Review and Evaluation of: A Site Assessment Report For Kentucky Pioneer Energy Case Number 2002-00312

Report Date: February 6, 2003

Kentucky State Board on Electrical Generation and Transmission Siting
211 Sower Boulevard
P.O. Box 615
Frankfort, Kentucky 40602

Jason Associates Corporation
808 Kalmia Hill Road
Aiken, South Carolina 29801
(803) 642-2304
(803) 642-2305 (facsimile)
<http://www.jason.com>
jrivers@jason.com

Figure C-1. Proposed Site Layout

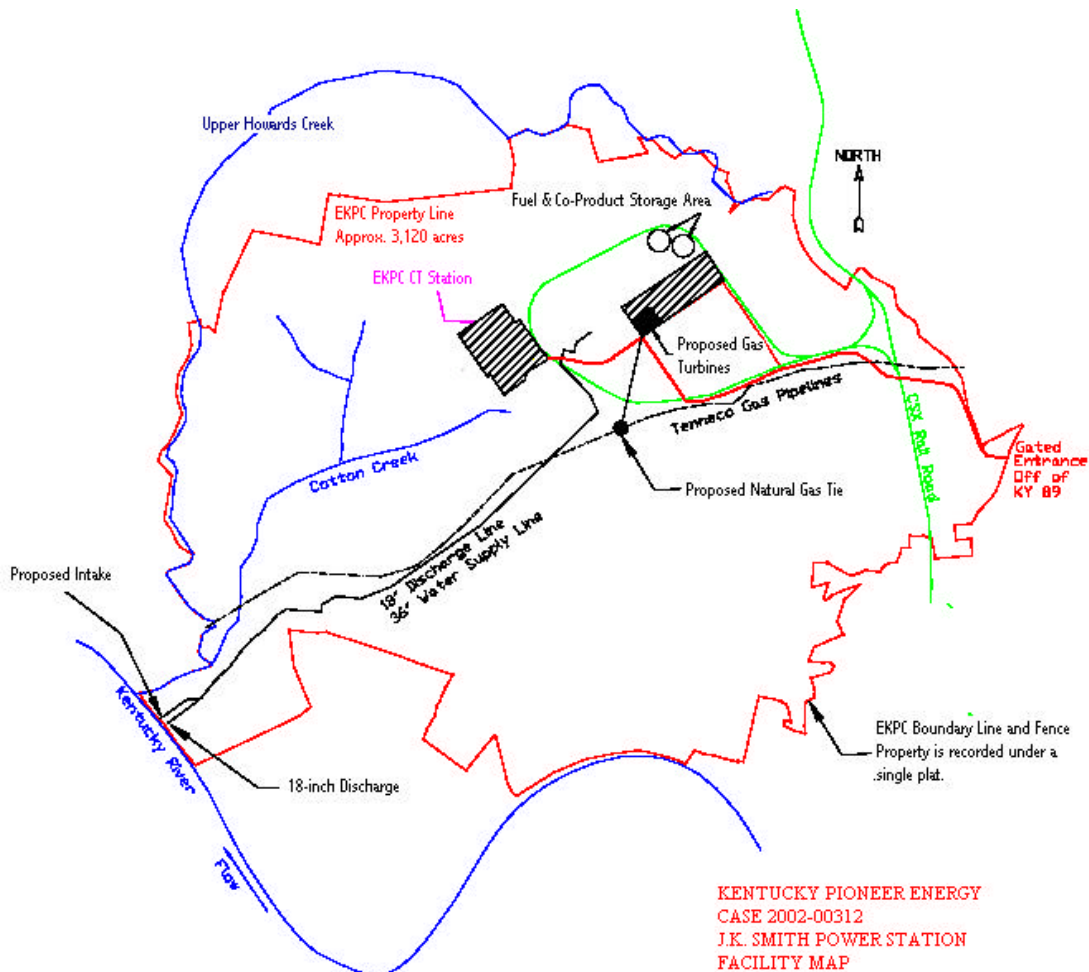
The Site Development Plan (SDP) states that there is no surveyed delineation of the KPE lease site. Rather, the lease generally identifies the rail loop, other areas, and certain buildings for joint and cooperative use.⁹ Figure C-1 provides an illustration of the site layout and relative locations of the KPE project and the EKPC site boundary.

Natural gas service will be required for startup of the facility. Natural gas pipelines from Tenneco currently traverse the site and are used by EKPC at their J.K. Smith site. KPE has stated that they expect to tie into an existing transmission line within the EKPC site boundary. Initial discussions regarding the tie-in have begun, but a specific tie-in location has not yet been identified. KPE provided a proposed tie-in location on their site layout provided earlier as Figure C-1.¹²
